2.0 SITE CHARACTERISTICS

2.0.2 Summary of Application

**FIGURE RAI 02.05.04-23-1
LOCAL FRACTURE SYSTEMS MODELED IN FEM**

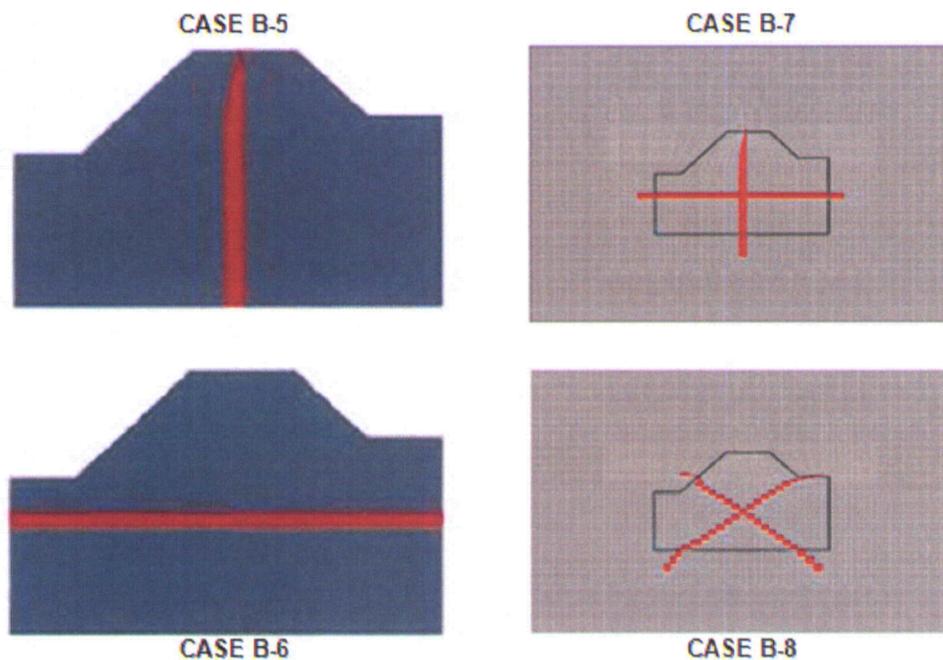
As modeled, the applicant stated that the 3.04 m (10 ft) fracture placed through the center of the nuclear island as shown in SER Figure 2.5.4-17 represents 100 fractures of 0.3 cm (0.1 ft) thickness and produces a maximum elastic settlement of 0.68 cm (0.27 in) and a differential settlement of 0.43 cm (0.17 in), which are less than the allowable settlement allowance of the AP1000 DCD.
